**Response to Comments**  
**on the**  
**Draft NEWIOU Feasibility Study**

## Response to CIWMB Comments on the Draft Feasibility Study for the NEWIOU

IRP Site SD036

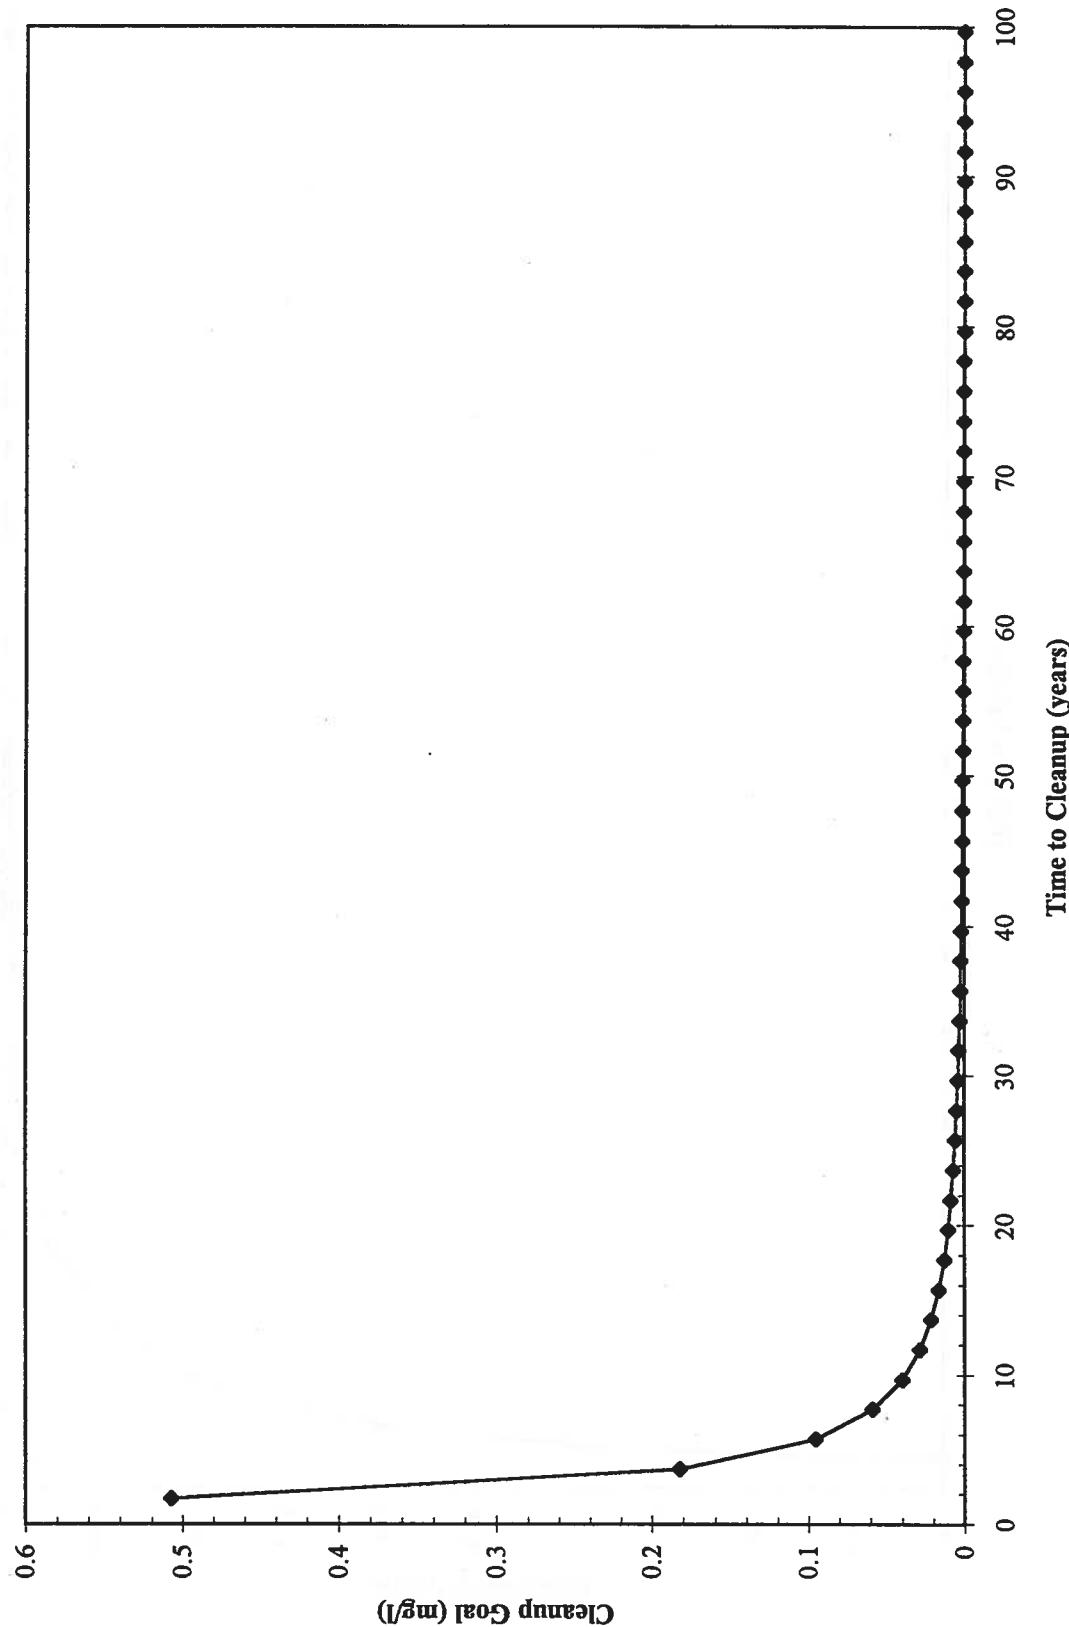
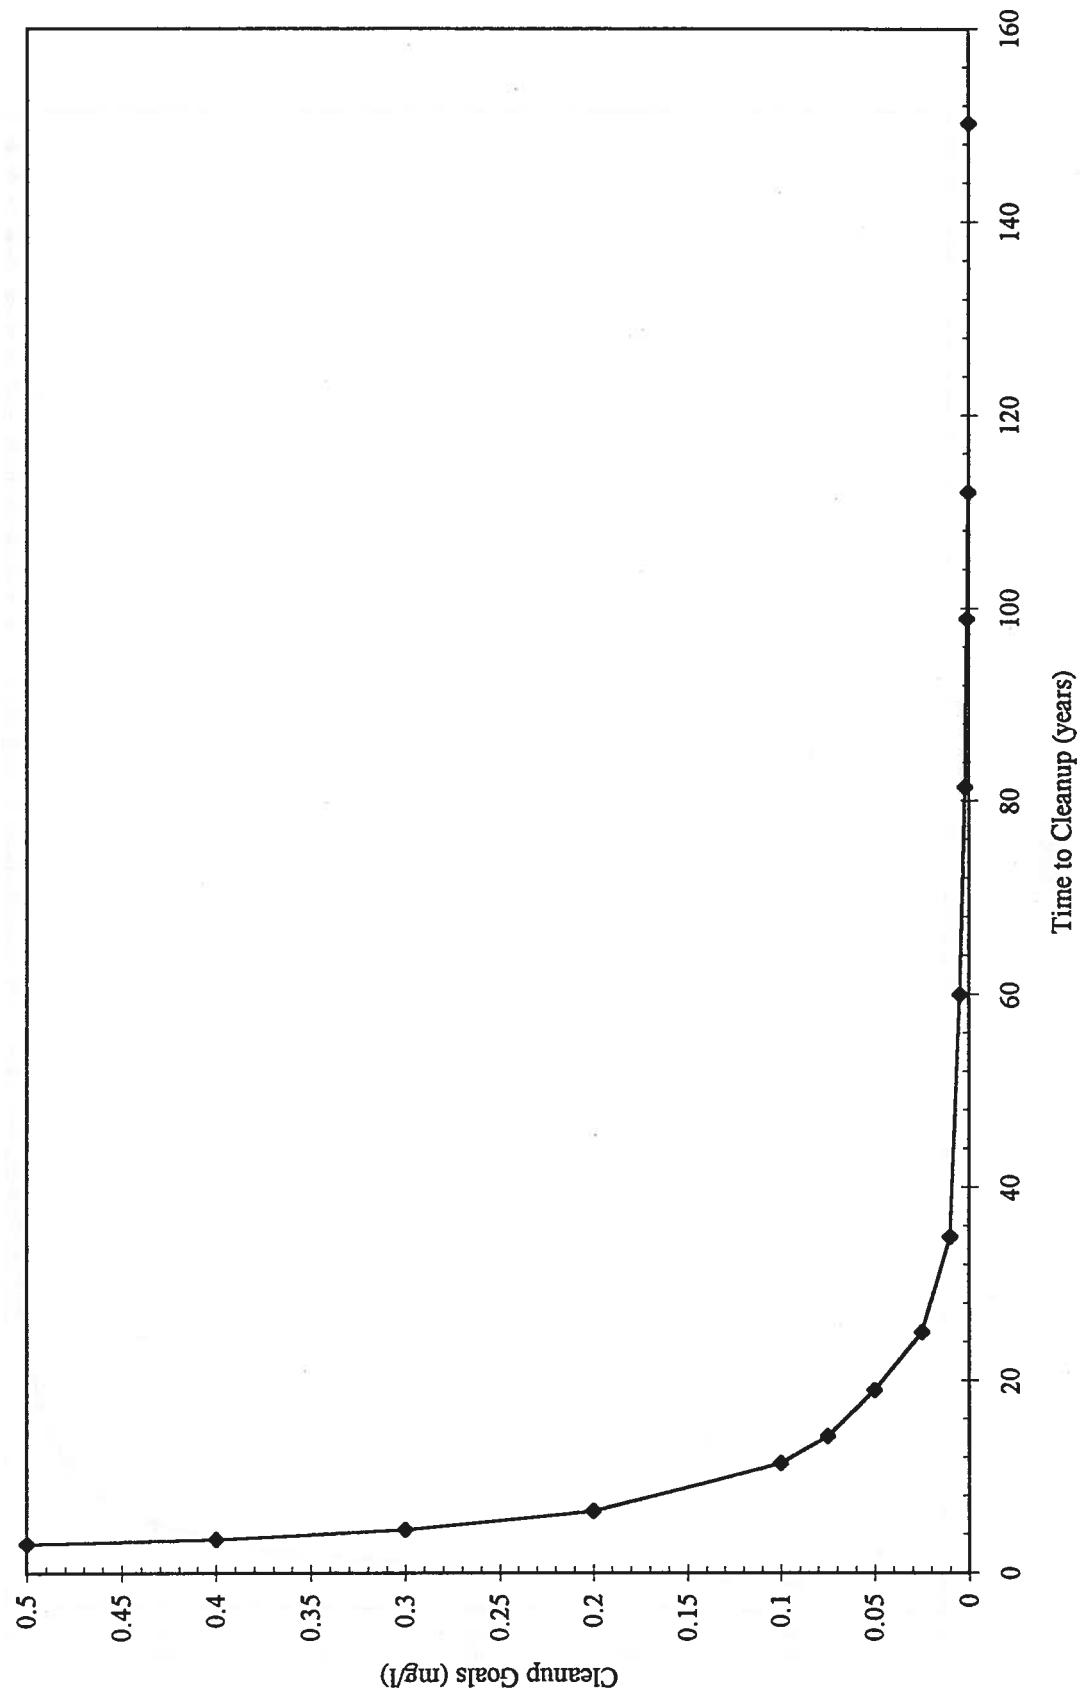
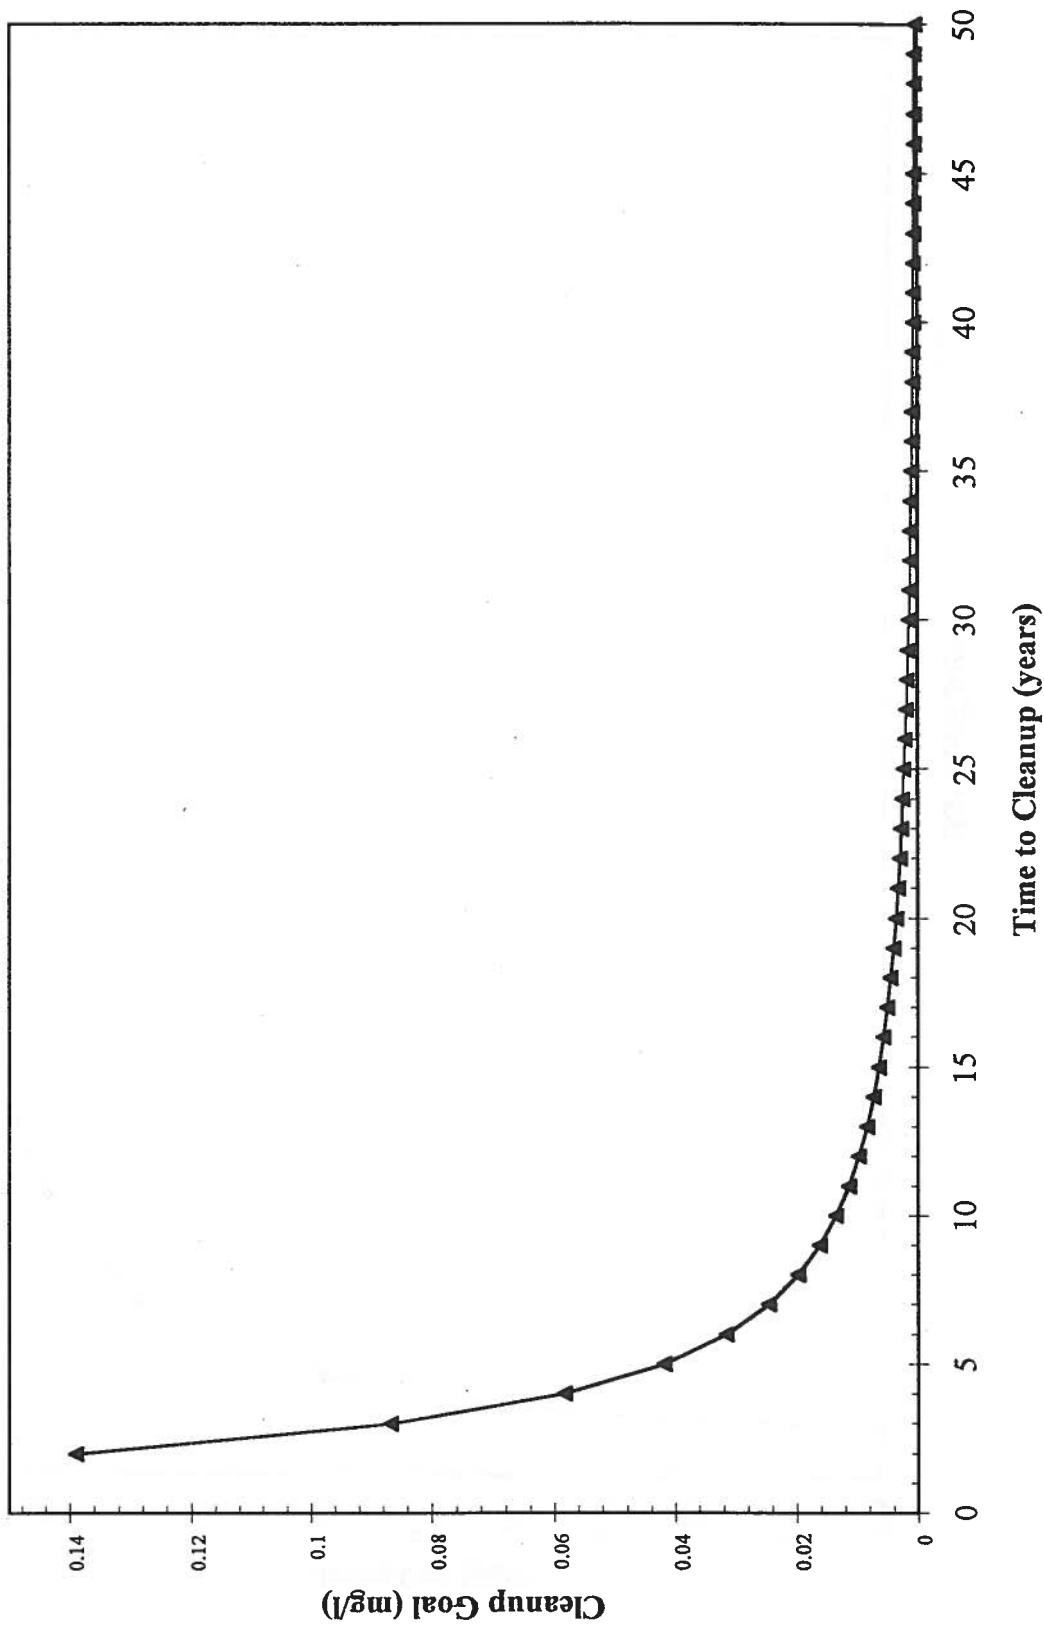
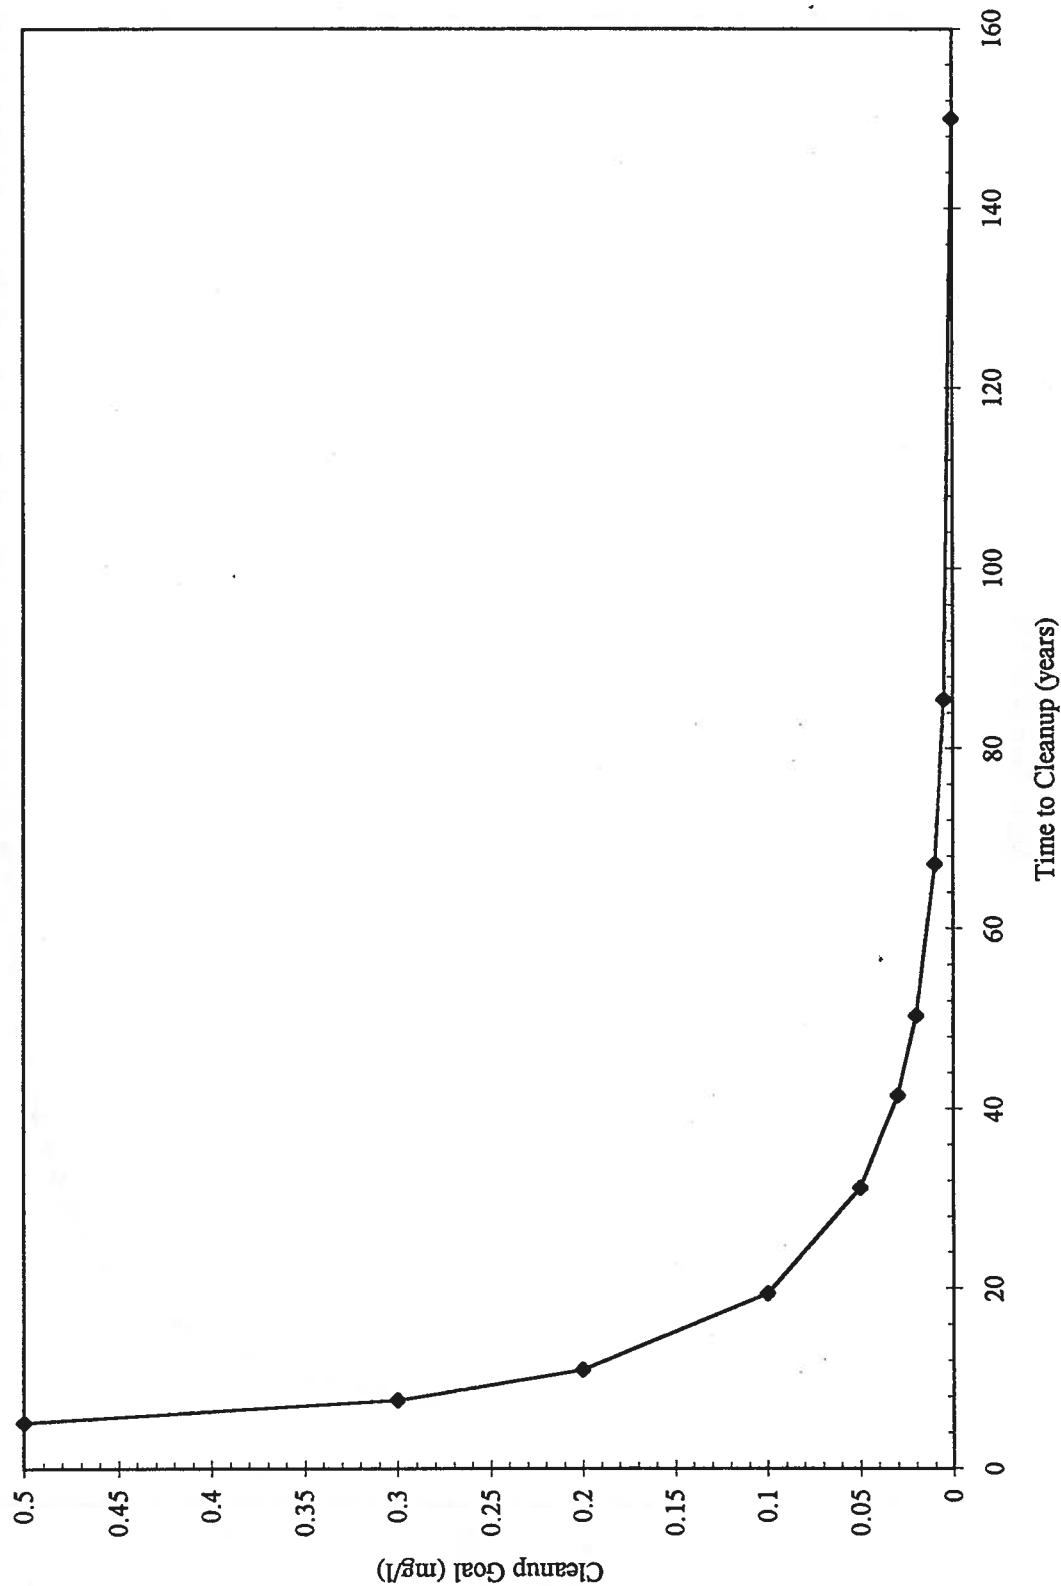
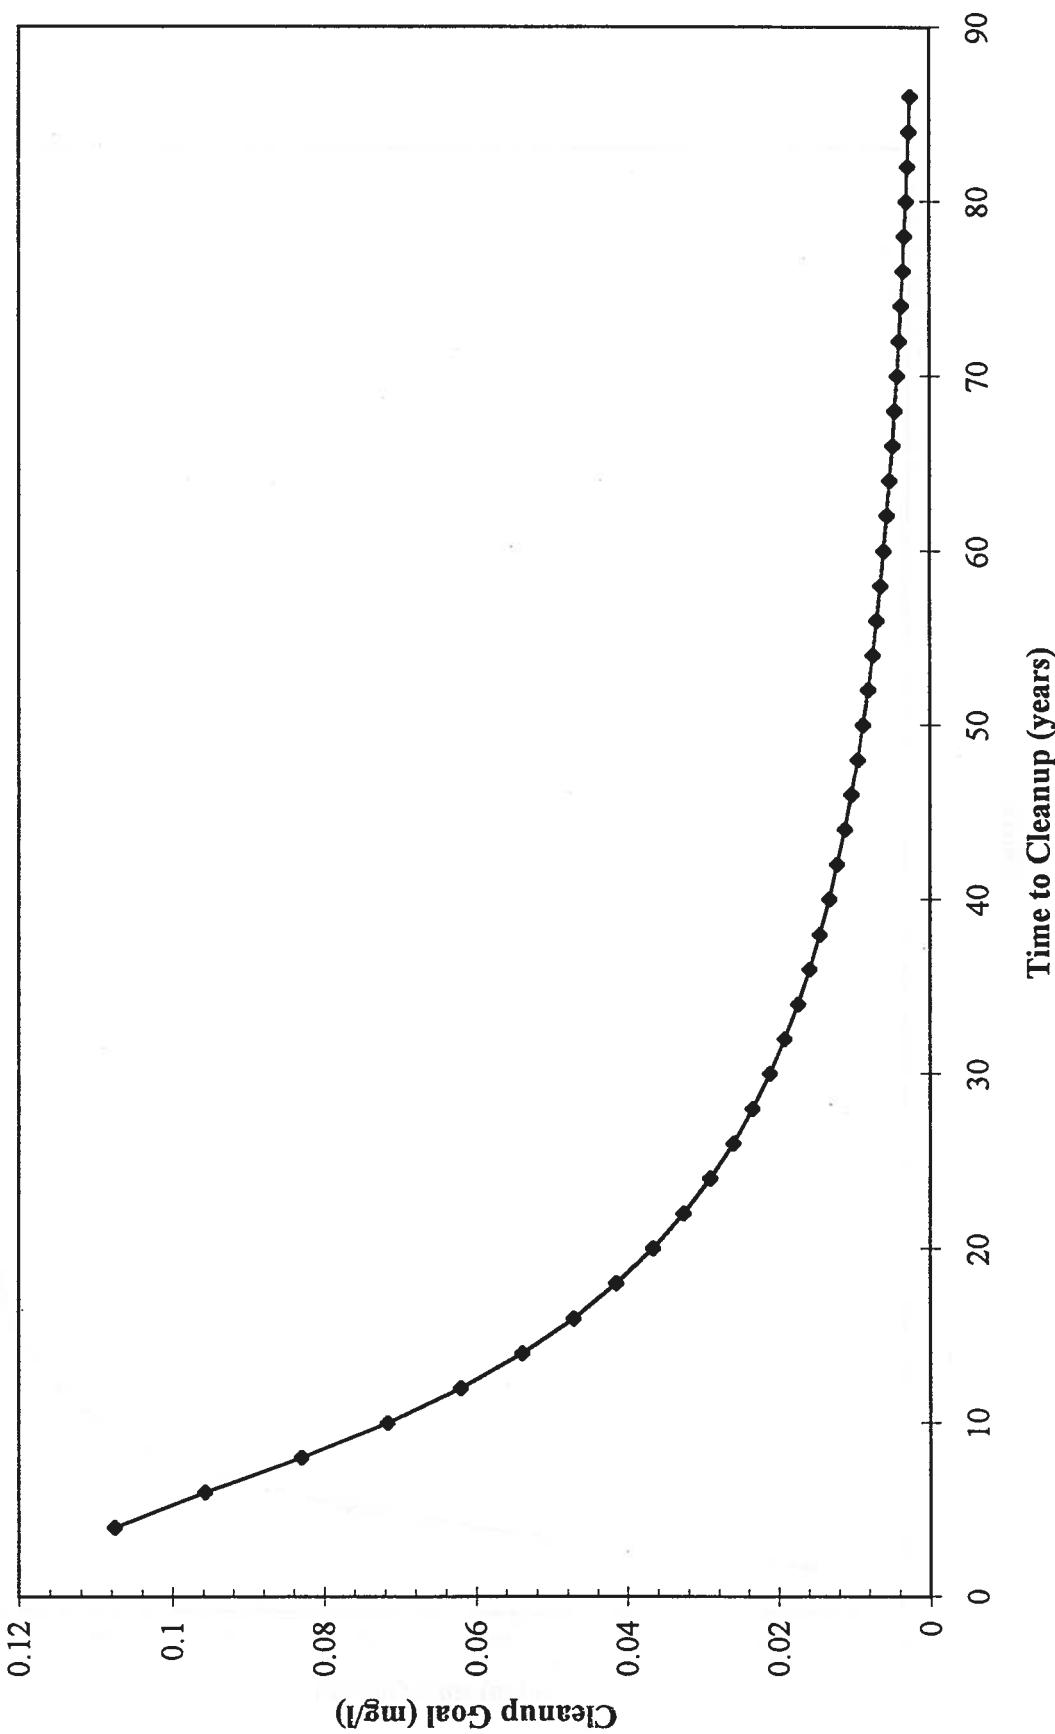
No.	Comments	Responses/Notes
13	<p><b>Appendix C, Time to Cleanup Determination Procedure</b></p> <p><b>Table C-10, Time to Cleanup Results</b></p> <p>For Group A sites, LF007B, LF007C, and LF007D, there is an apparent discrepancy in the calculated time to clean up the corresponding plumes and the relative size of those plumes. For example, the plumes under LF007D and LF007B are larger than the plume under LF007C and yet the calculated clean up time for LF007C is approximately ten times greater than LF007D and LF007B. DTSC recommends that the calculations be redone to check for possible errors. If the calculations are correct, then a discussion is needed to explain why there is such a large variation in cleanup times between LF007C and LF007B/LF007D. Any changes made to this table will also require modification of corresponding figures and discussion in the rest of the report.</p>	<p>The calculations for LF006 and LF007C were incorrect. The times to cleanup LF006 and LF007C should be lower. These times to cleanup have been corrected. In addition, an explanation of the following differences will be added to the Appendix: LF007B and LF007D were modeled based on chlorobenzene, while LF007C was modeled based on TCE, as noted in the summary table. In addition, LF007B and LF007C were modeled for linear flow through the plume, while LF007D was modeled for radial flow from the center of the plume.</p>
